**Council File No:** 25-1518

**Comments for Public Posting:** Please add document "Barry Building Stairs and Benches Salvage Plan OHR Mark-up Feb 2024.pdf" to Council File 25-1518.  
Thank you.

**Barry Building  
Stairs & Benches Safekeeping**

**Report**  
of  
**James C. Wolf**

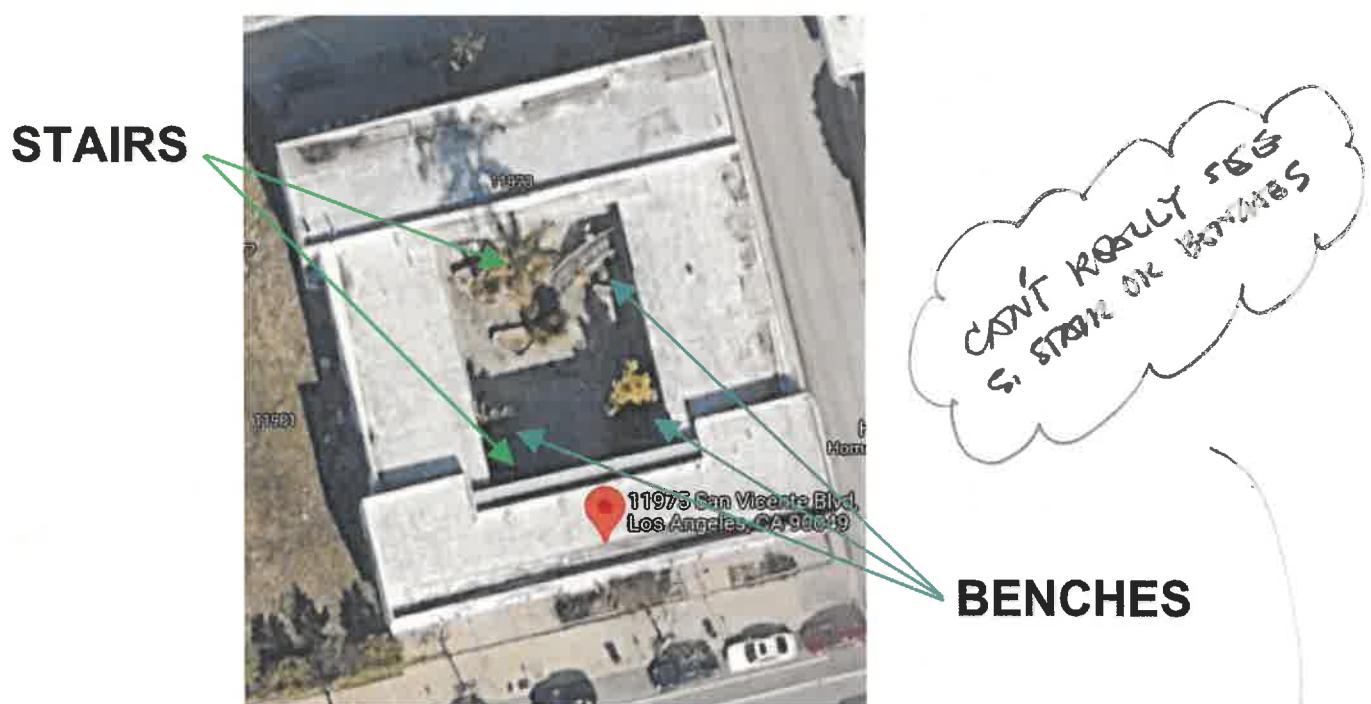
ORIGINAL PLANS  
EXCLUDED THE  
STAIRS & BENCHES  
INCLINING  
BARRIER  
PLATE  
WHAT NOT  
HABBS  
OR WHICH PRIORITY?

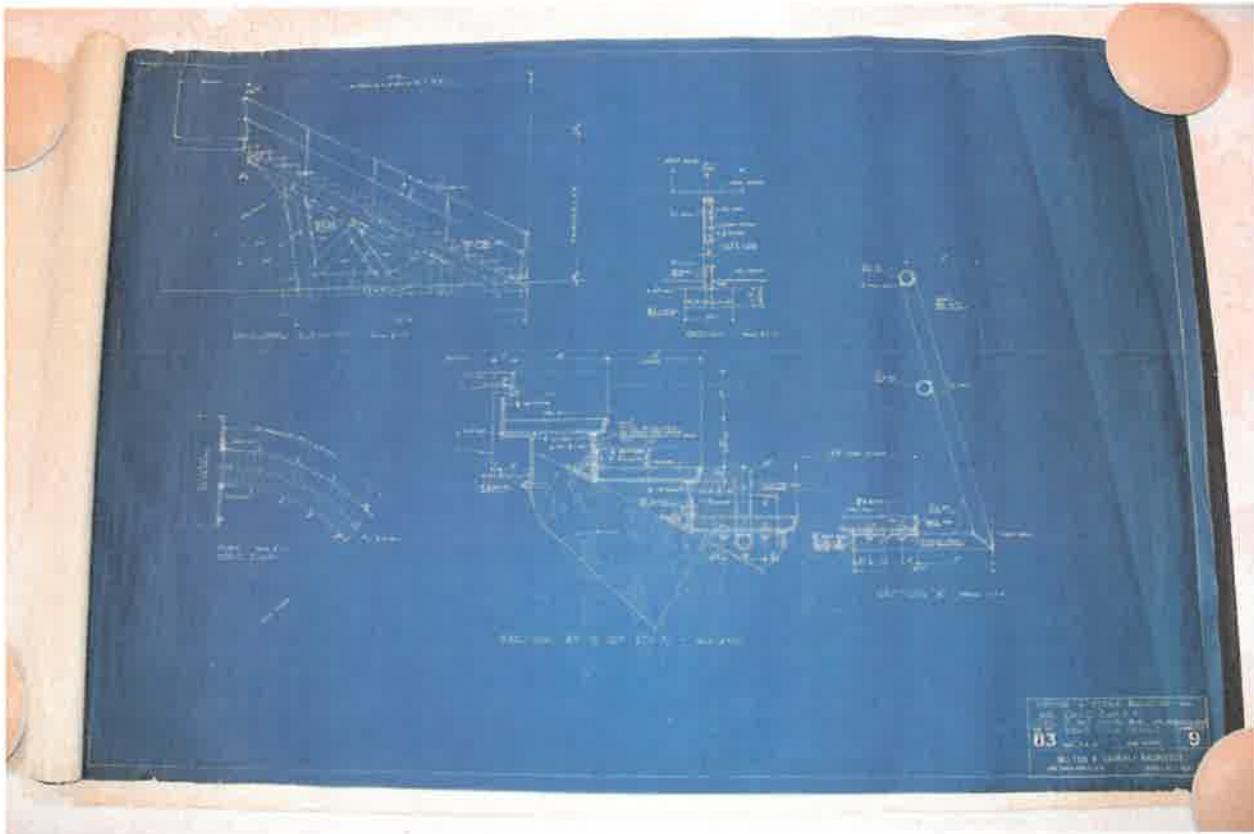
DISCUSS BENEFITS / WHY 2 OPTIONS?  
WHAT HAPPENS TO THE TREADS + RAILINGS?

**Storage:** The benches can be crated and stored on-site. ← ?
